ADDENDUM NO. 1

ISSUE DATE: **May 3, 2018**

RE: **Sterling Hall Renovation for TREX Physics**
University of Wisconsin-Madison
Madison, Wisconsin
UW-Madison Project No. **0057-1701**
UWSA Project No. **A-17-003**

FROM: KEE Architecture, Inc.
621 Williamson Street
Madison, Wisconsin 53703

6 CRANE HANGER SECTION
S800.2 SCALE: 1 1/2" = 1'-0"

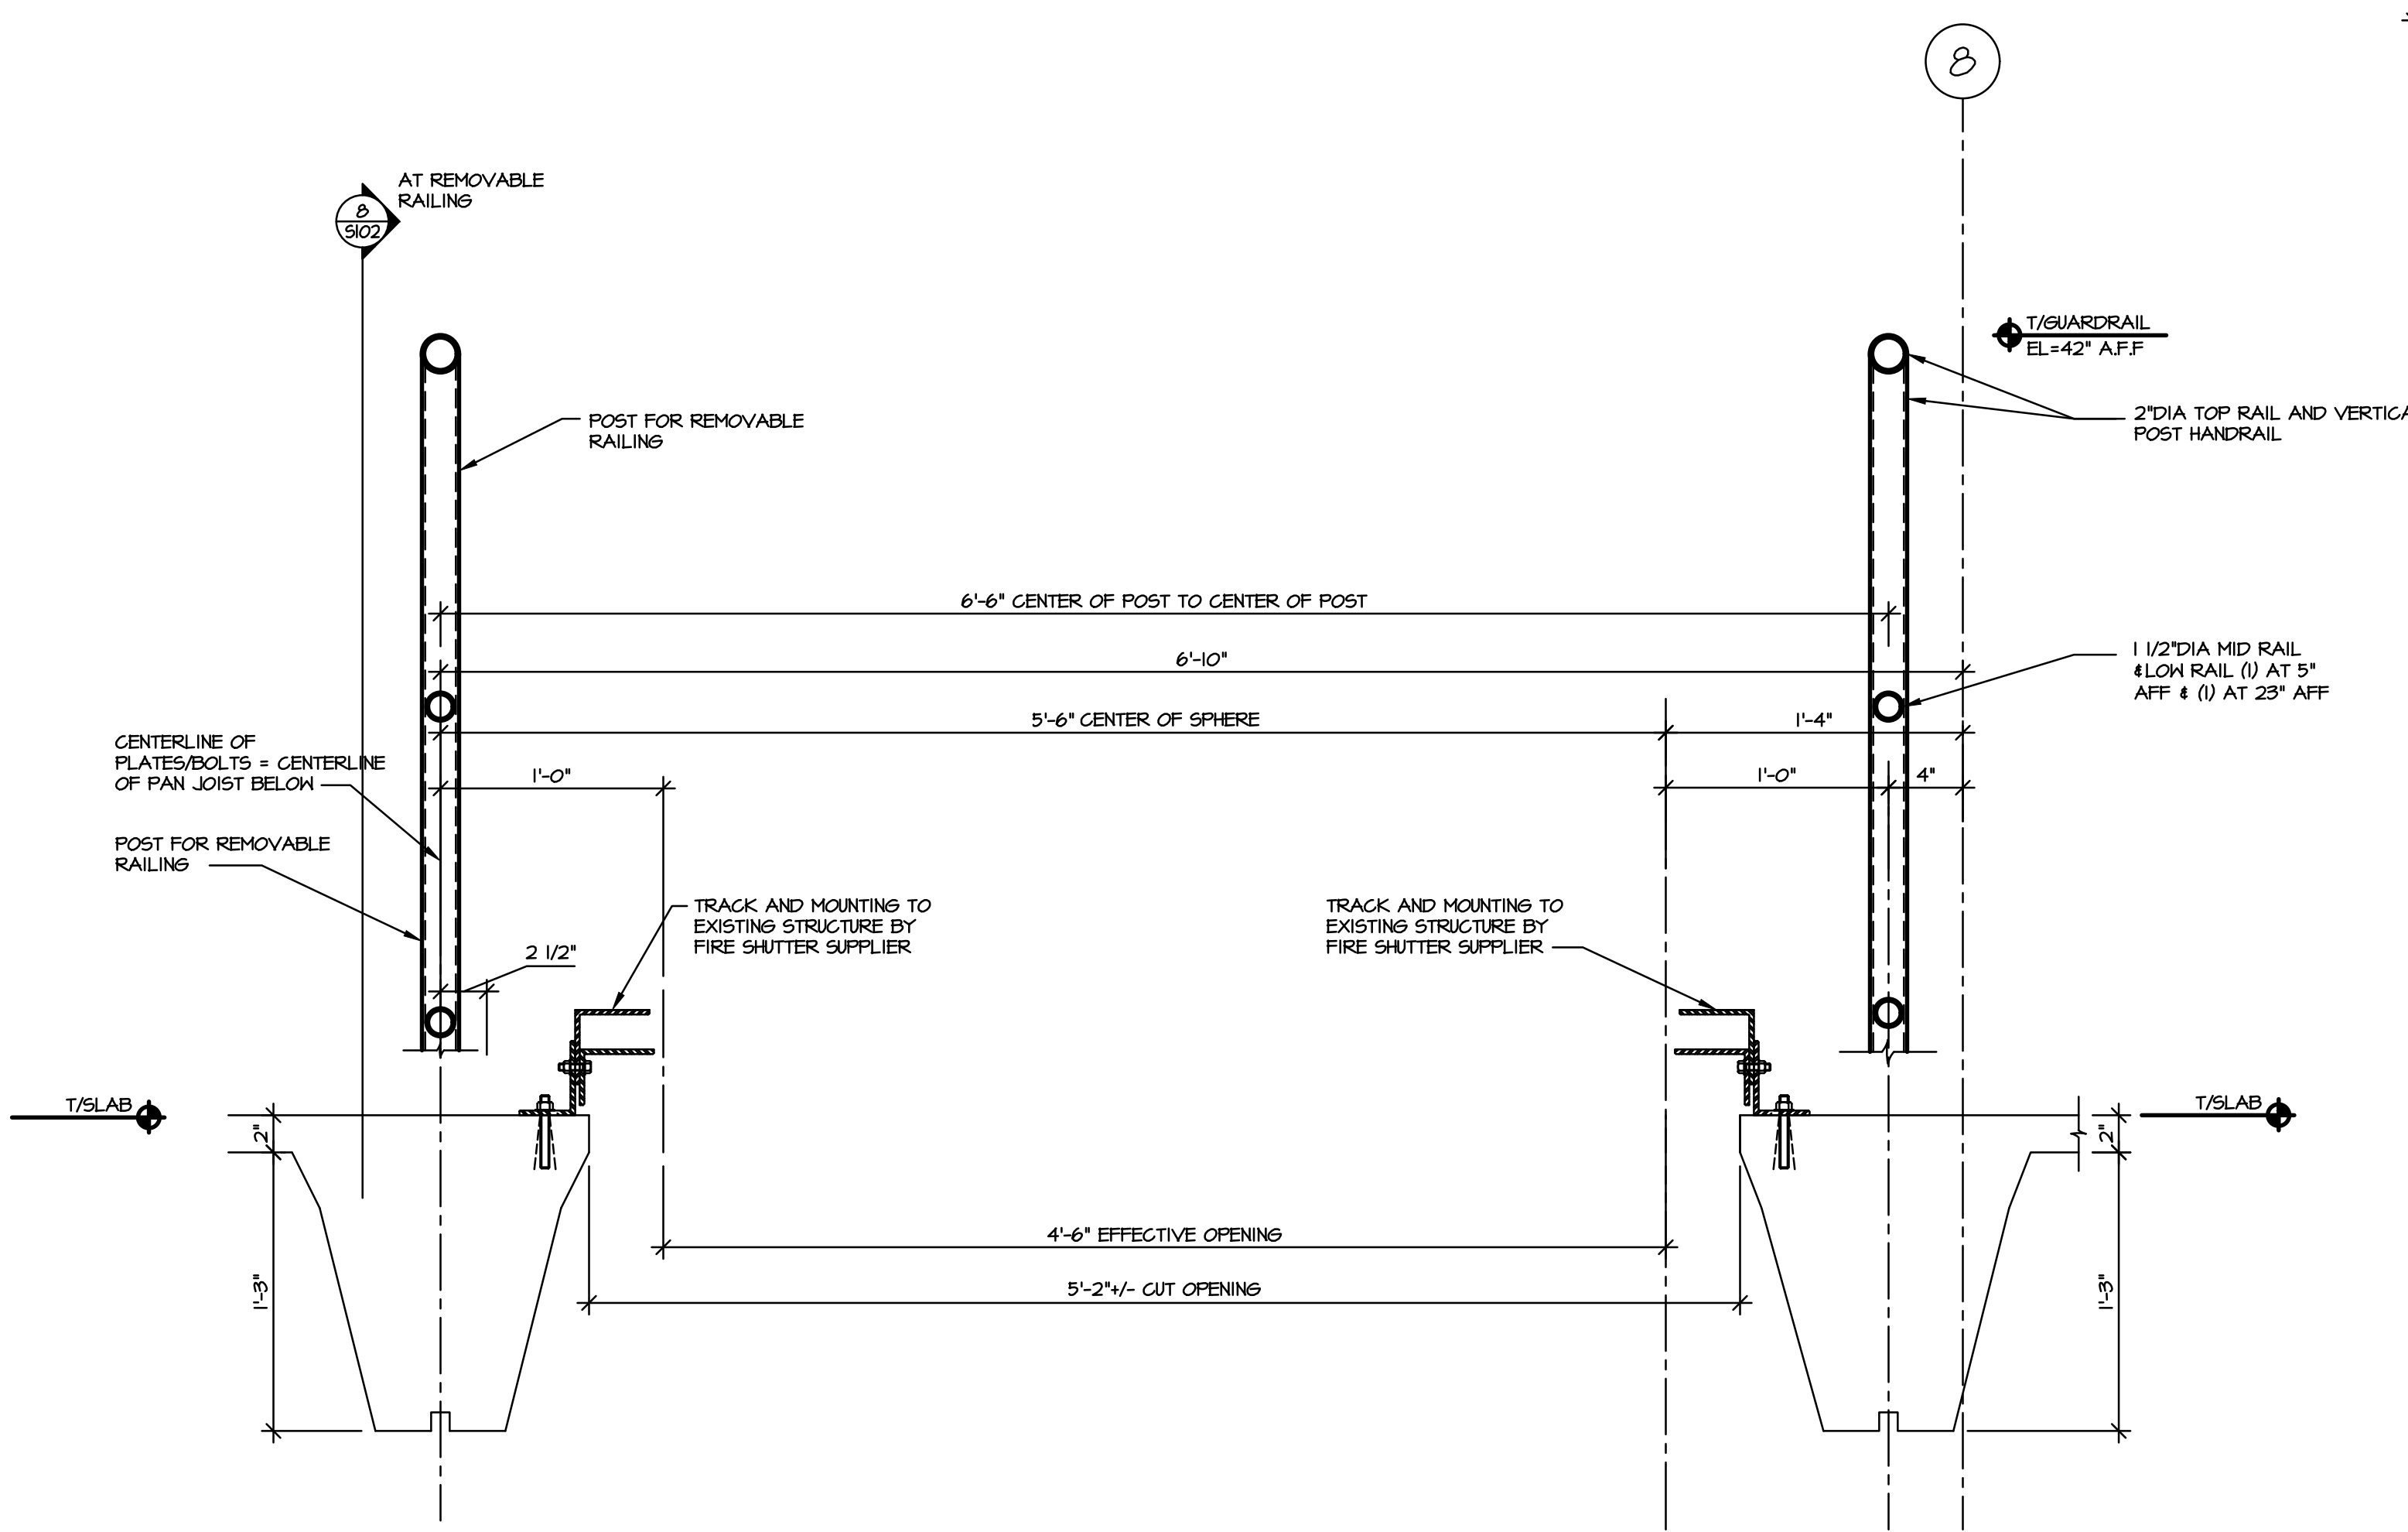
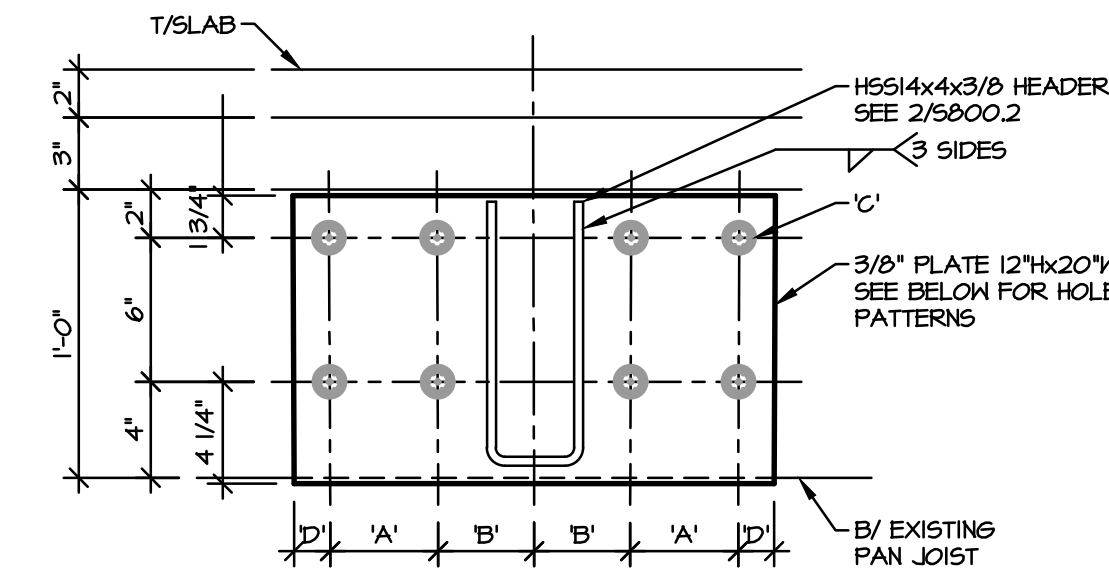
18. S800.2 – Details (FS Option 2): Added Sheet.
 - a. Details 1, 2, 3, and 4 this sheet are all substantially different for the FS Option 2.
19. A202 – Partial First Floor Plan (Demolition): Replaced sheet

Revisions:		
No.	Date:	Description:
	05/03/2018	Addendum 1
Graphic Scale		
Project Numbers:	UWSA: A-17-003 MSN: 0057-1701	
Set Type:	BD	
Date Issued:	04/06/2018	
Sheet Number	A202

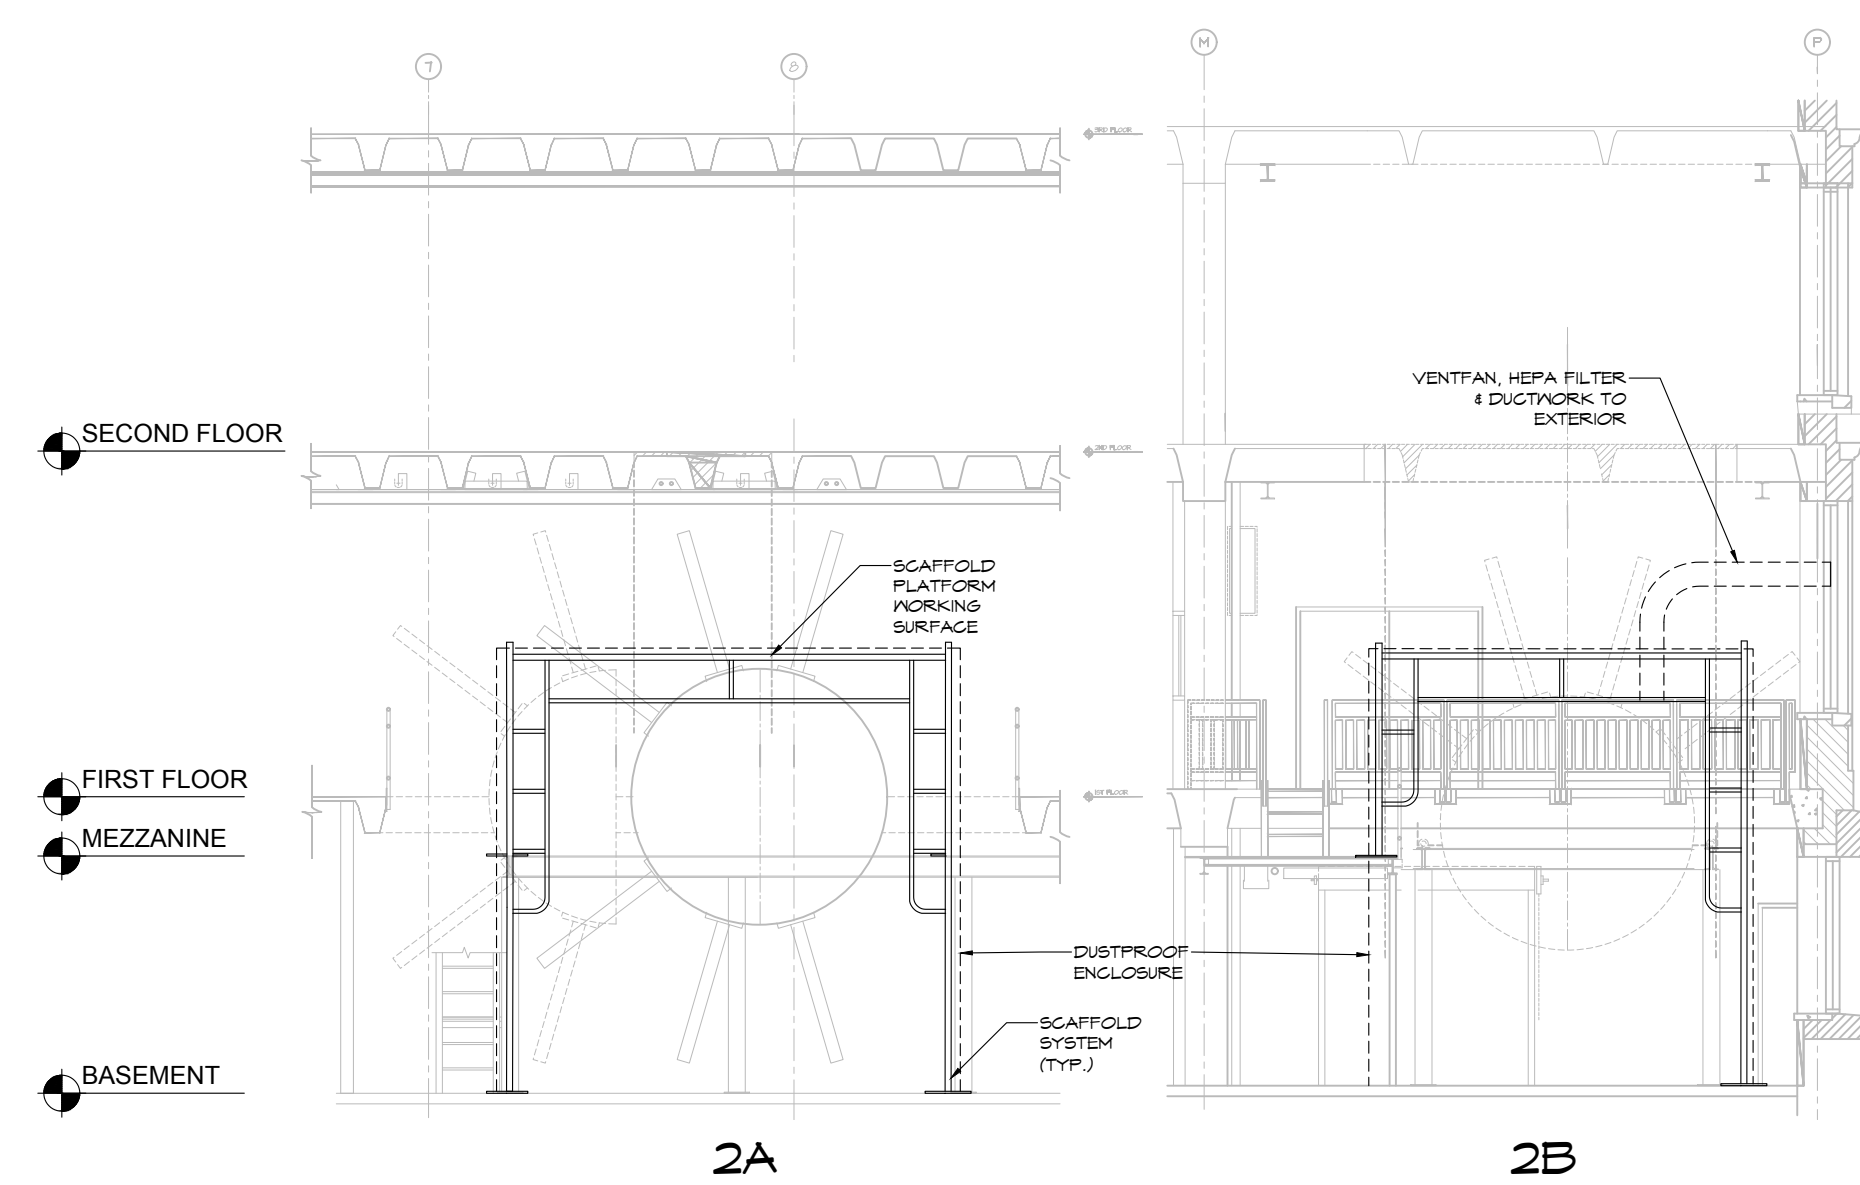
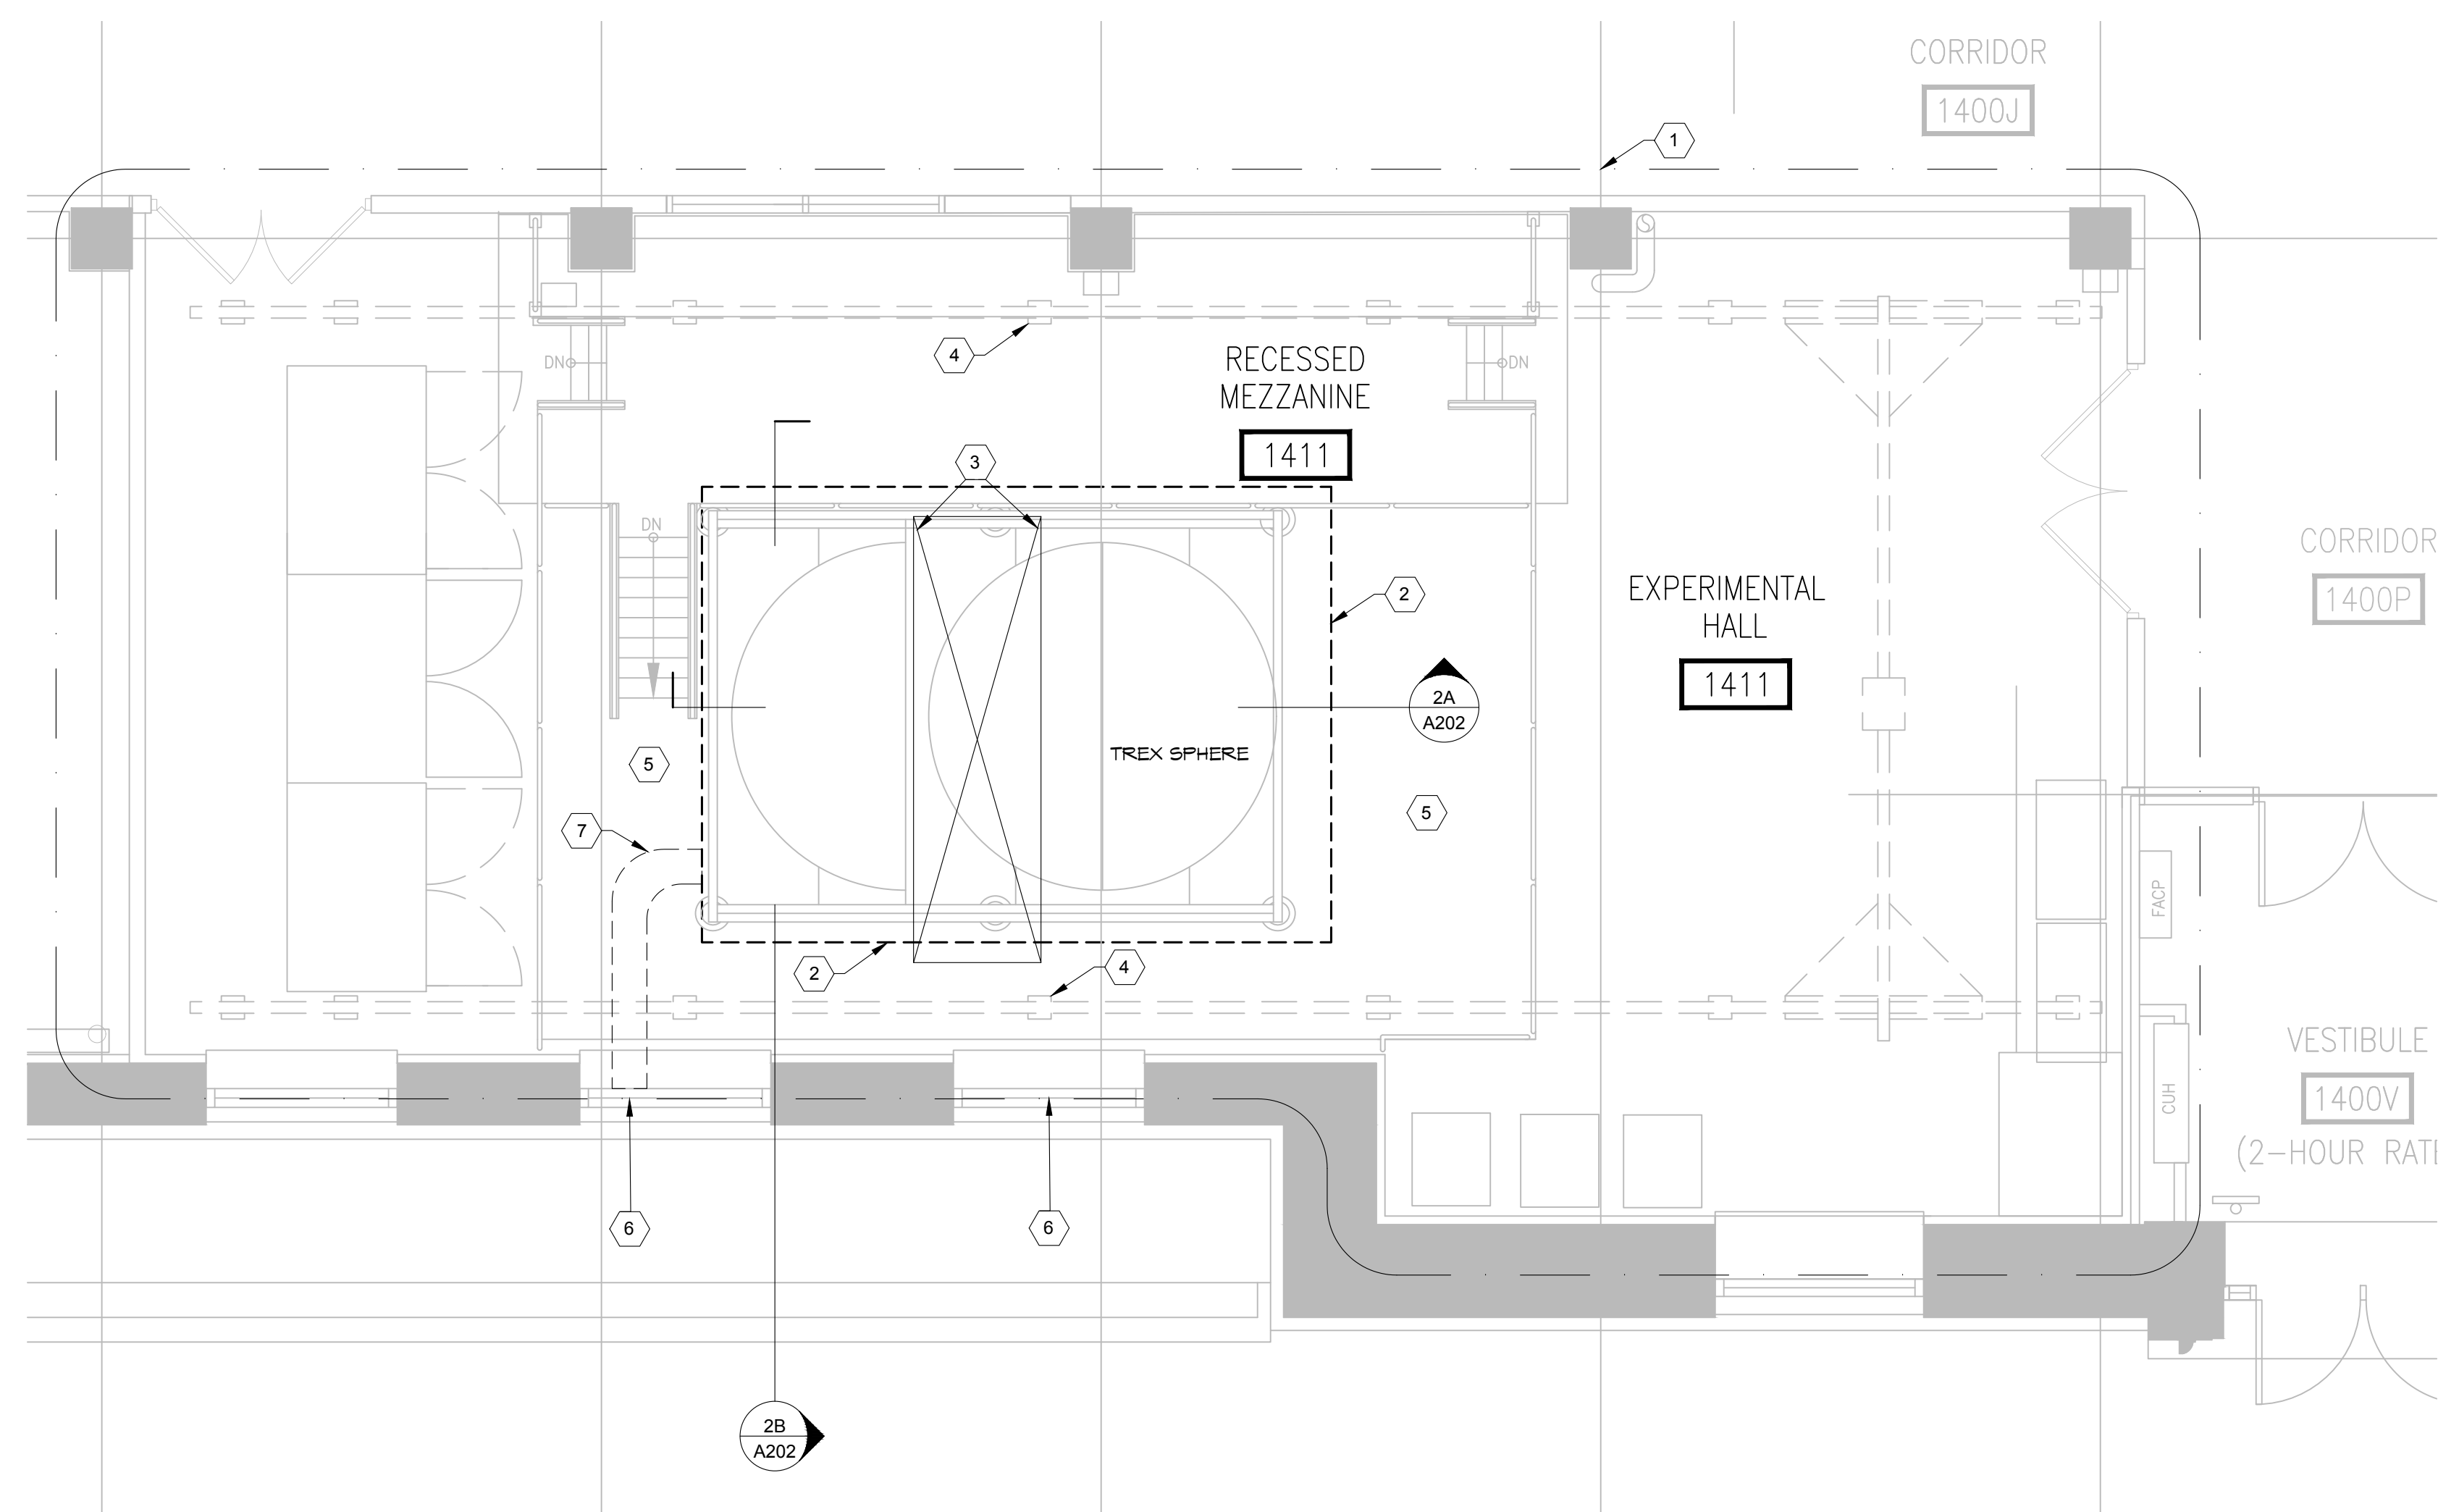
- a. Revised keynotes 3 and 4.
20. A203 – Partial Second Floor Plan (Demolition): Replaced sheet
 - a. Revised as indicated.
 - b. Revised keynotes 3, 6, and 10.
